**The W Nursing School
Neshoba General
Philadelphia, MS**

Addendum No. 5

June 17, 2026

This addendum forms a part of the contract documents and modifies the original plans and specifications dated June 4, 2026.

3 SECTION AT DESKS
1 1/2" = 1'-0"

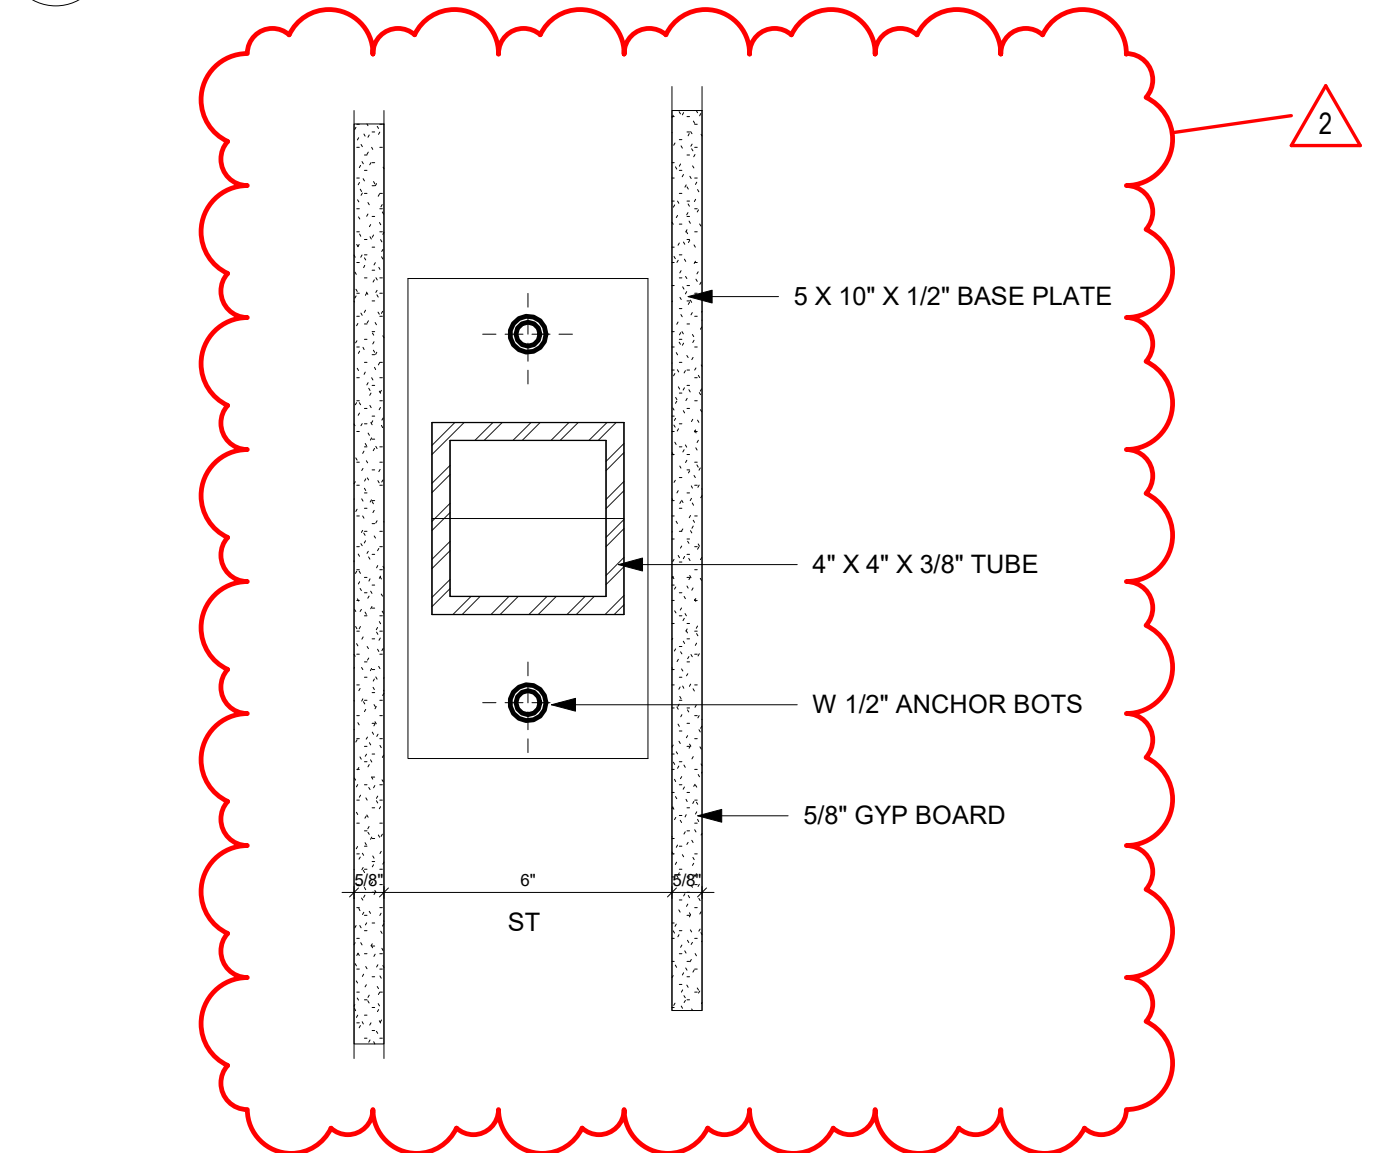
Note: Provide desktop receptacles and duplex receptacles below counter as noted in detail 3/A105.

6 LAB 314 NORTH
3/8" = 1'-0"

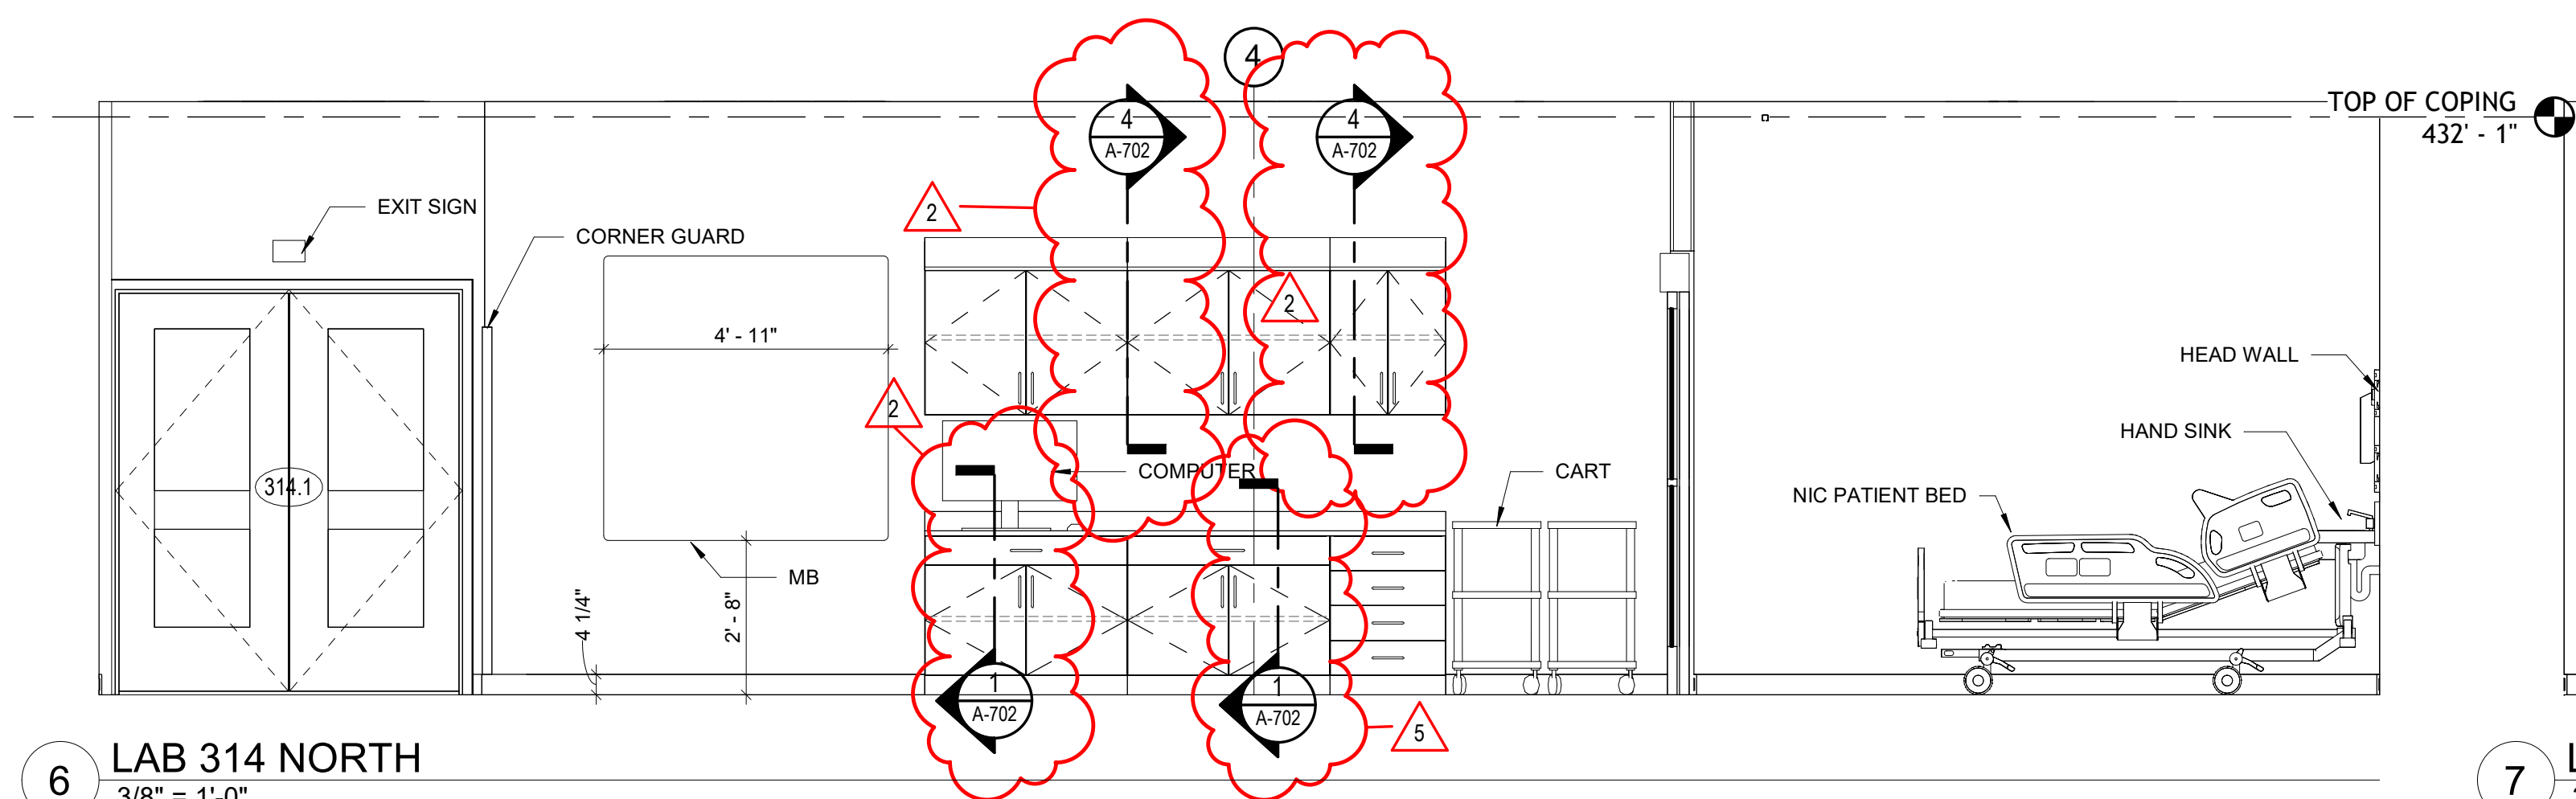
Change: 3/A702 to 1/A702

7 LAB 314 SOUTH
3/8" = 1'-0"

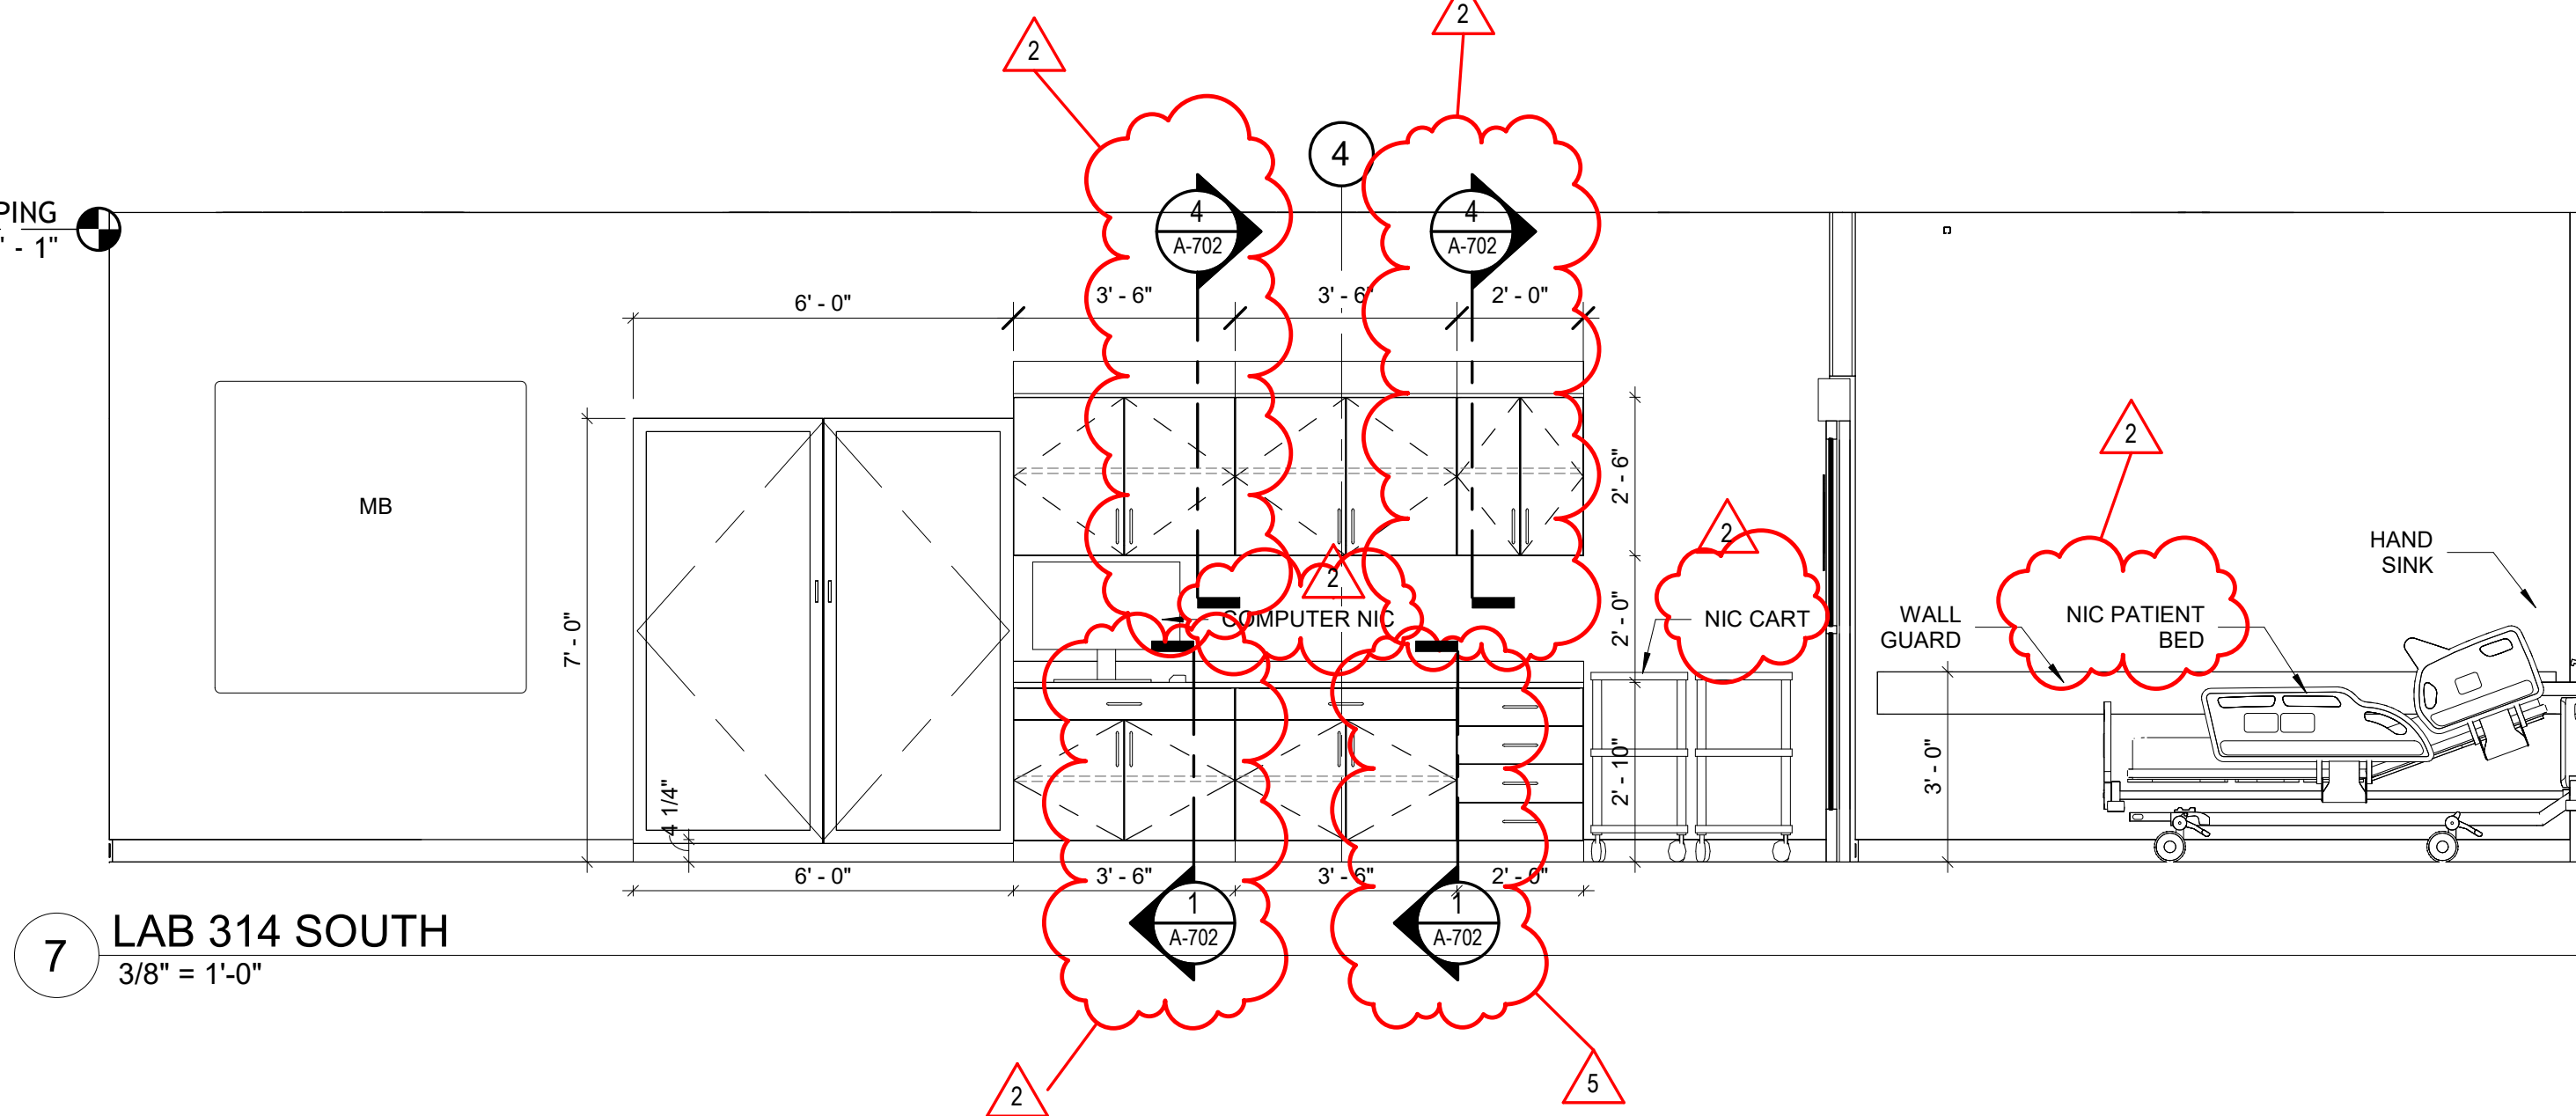
Change: 3/A702 to 1/A702

4 30" COUNTER W/ KNEESPACE
1 1/2" = 1'-0"

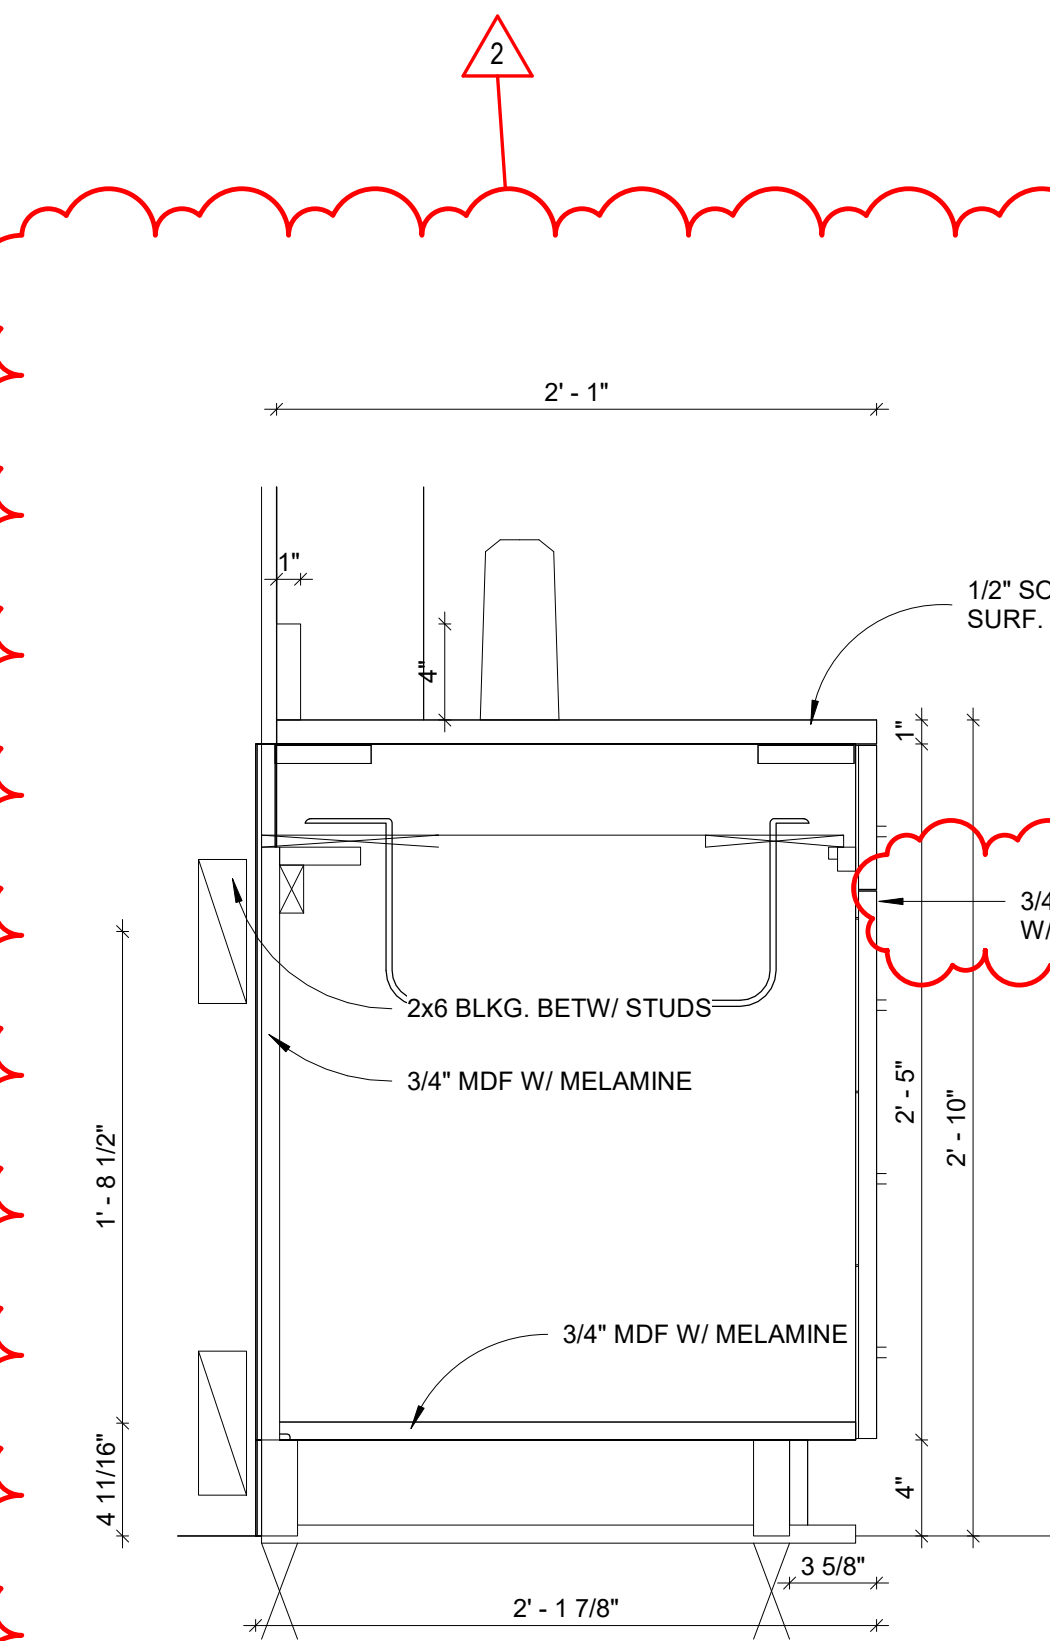
Change: $\frac{3}{4}$ " plywood with P. Lam

To: $\frac{1}{2}$ " solid surface
